Review of the Roxwind LLC Project Scenic Resource Impact Assessment

by Terrance J. DeWan & Associates (TJD&A)

*Prepared by: LandWorks, Middlebury, VT
Prepared for: Maine Department of Environmental Protection*

November 7, 2018

View gap to Tumbledown Mountain

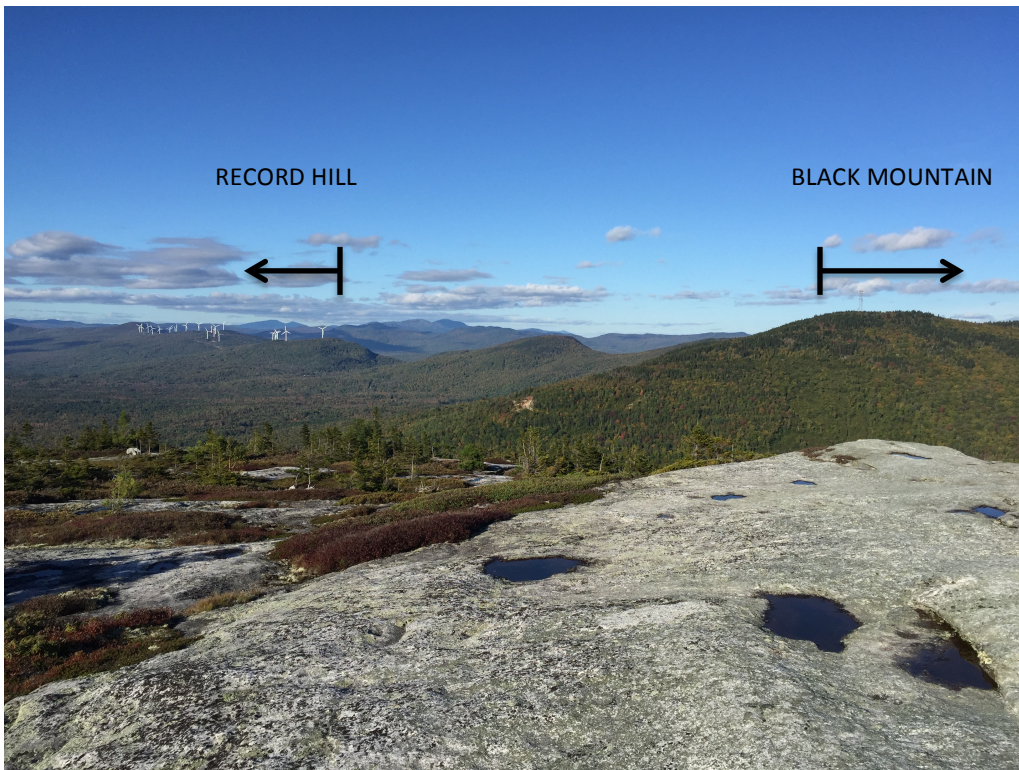
The site visit and analysis yielded the real concern that the proposed Roxwind project will "close the viewing gap" that now exists between the Record Hill project and the utility structures on the Black Mountain summit. This provides the viewer with some visual relief and a long distance view to Tumbledown Mountain and the rugged landscapes to the northeast.

Currently there are another four wind energy projects in the 360-degree view with a fifth in the distance towards the west in NH – one is beyond the 8 mile radius however. These are readily visible on clear days. The addition of this new project would

essentially surround at least 1/2 to 3/4 of the summit view with views of large/grid scale turbine projects so there is a distinct potential that some viewers will find that the Roxwind project with its proximate location adds a level of encroachment that changes the effect (or summit “feel”) and experience of the summit. The Record Hill project is just far enough away, and the gap between it and the industrial elements on Black Mountain separates the two intrusions sufficiently to accommodate them without substantively undermining the view. The concern is that this will change with the advent of the new turbines.

Figure 1: View Looking East from Summit of Whitecap Mountain, 10/5/18

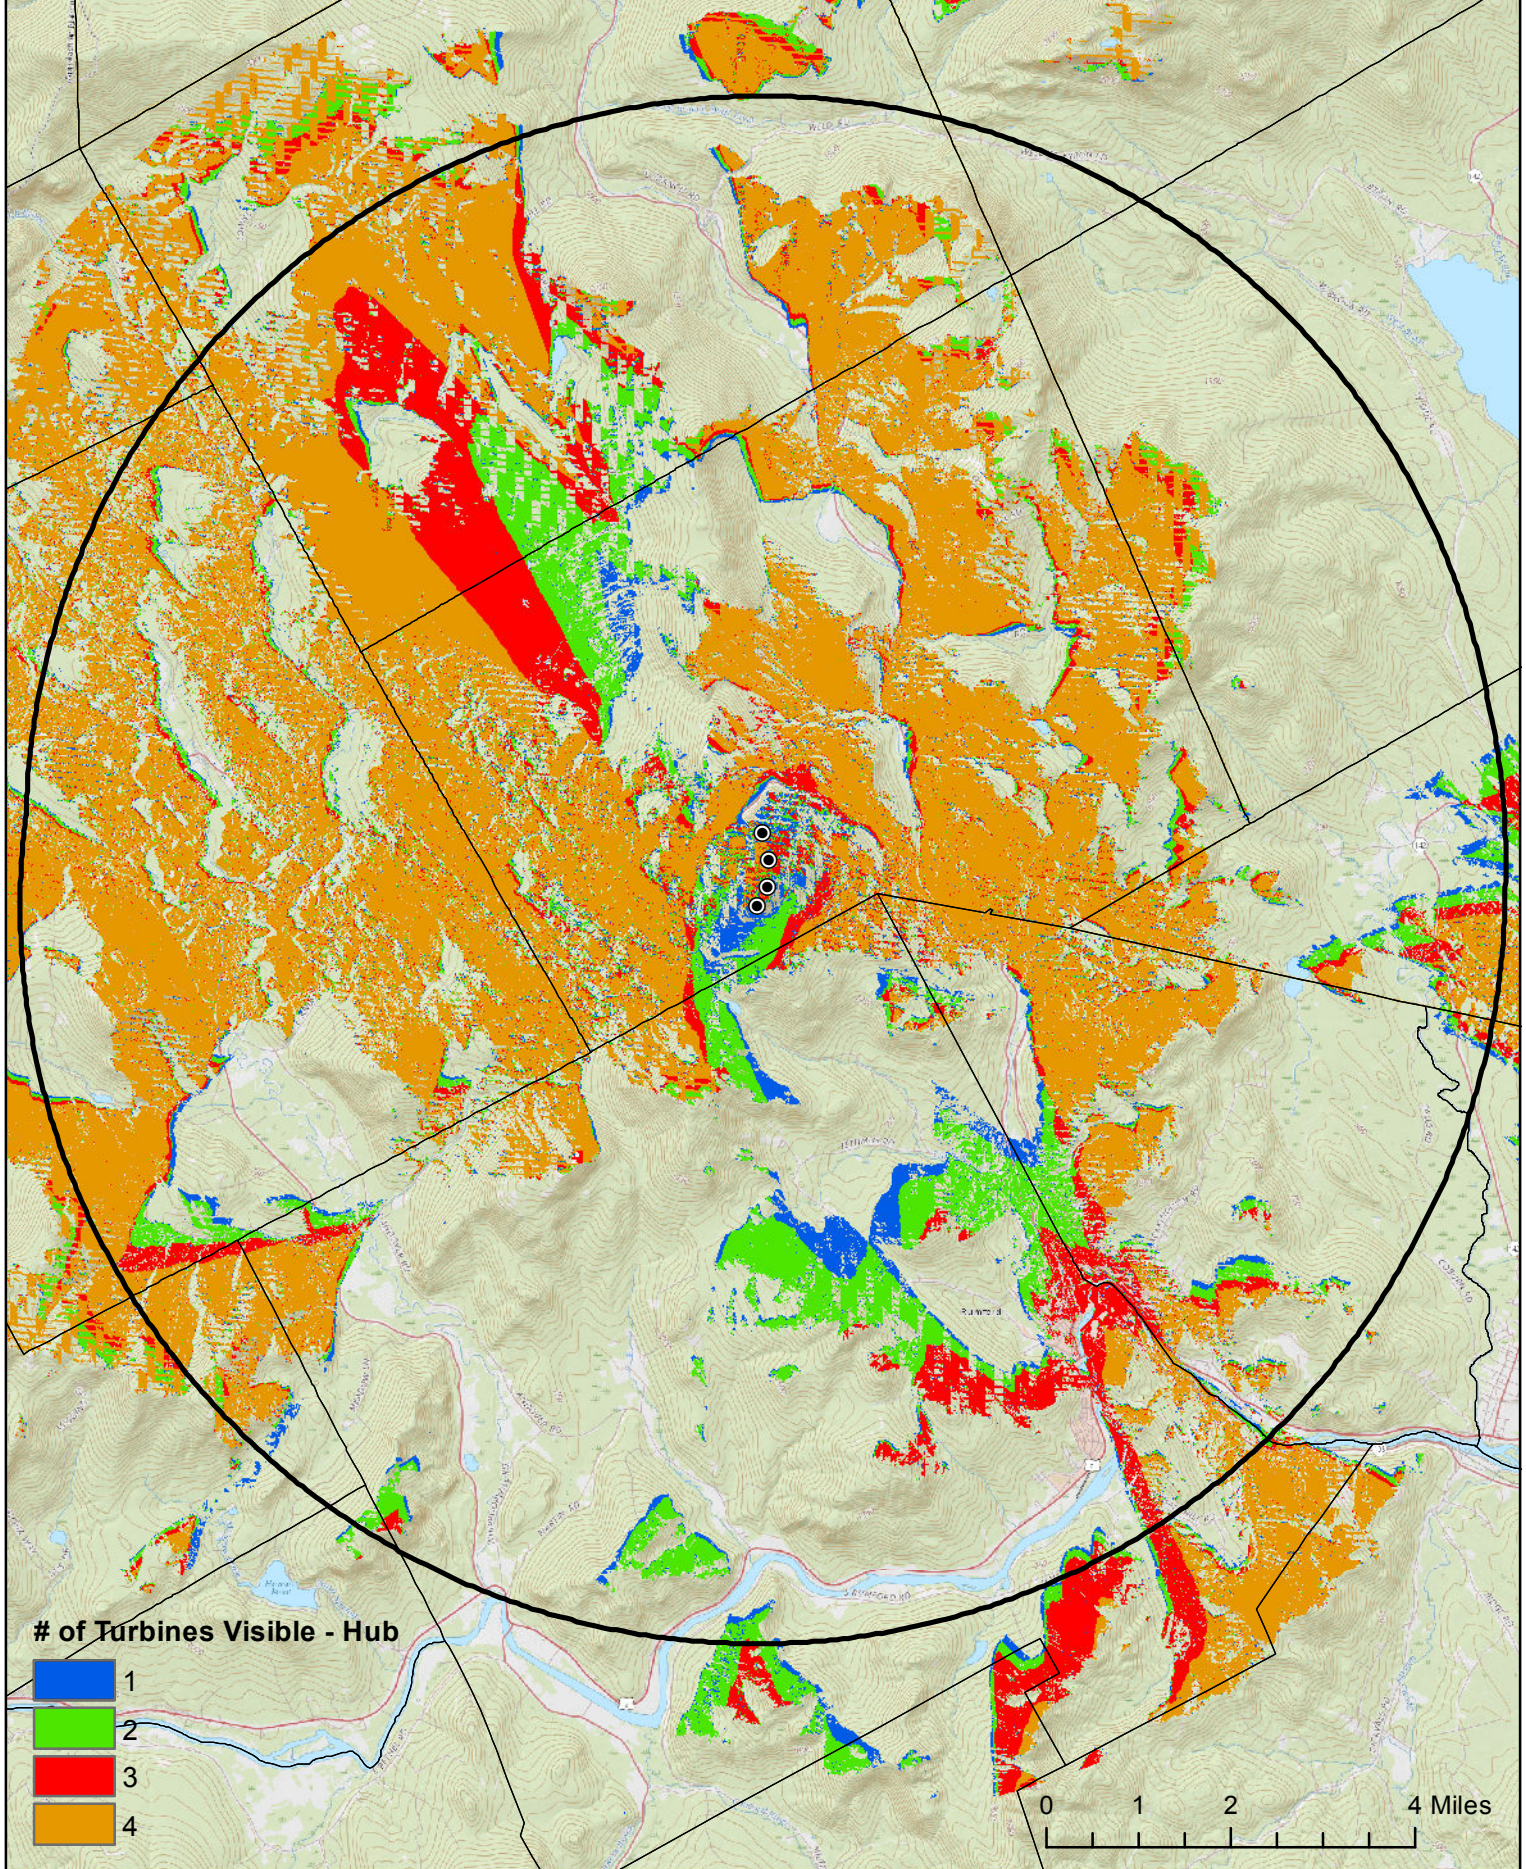
As stated previously, the Whitecap summit should be reclassified or understood as a scenic resource of statewide significance, and given some of the project factors there is the potential for an unreasonable (and cumulative) effect on the view from the summit of the mountain. This is due in particular to the change from an intermittent array of summit structures to a continuous panorama from Record Hill to North Twin (the Roxwind site) to the structures visible on Black Mountain. While the structures on Black Mountain are not wind turbines, they are part of the view, and when taken together with Record Hill and the proposed Roxwind Project, the sum of these visible elements will cause a potential adverse effect on the scenic character experienced from the summit of Whitecap. There is no discussion, for example, as to how the scale and extent (scope) of the new project combined with the Record Hill project, as well as the separate structures on Black Mountain, might reach a threshold of unreasonable visual effect – or how it won’t exceed that threshold. Whitecap is highly valued by its user group, is a prominent and highly accessible alpine summit, and has current views today to the northeast mountains that will be altered and undermined with the advent of the Roxwind Project.

1. It is recommended that the applicant revisit the analysis of Whitecap Mountain with a more robust accounting of the nature and duration of the public’s use of the resource. There also needs to be presented a substantive rationale for how the project will not unreasonably adversely affect continued use and enjoyment of Whitecap, and a more extensive account of how this project will not unreasonably

2. It is recommended that a user survey be conducted to address the effect on scenic character and the viewer's/user's continued use and enjoyment of the resource.
3. The applicant should conduct a more detailed analysis of the potential cumulative effects posed by this project within the framework of concerns set forth in this report.
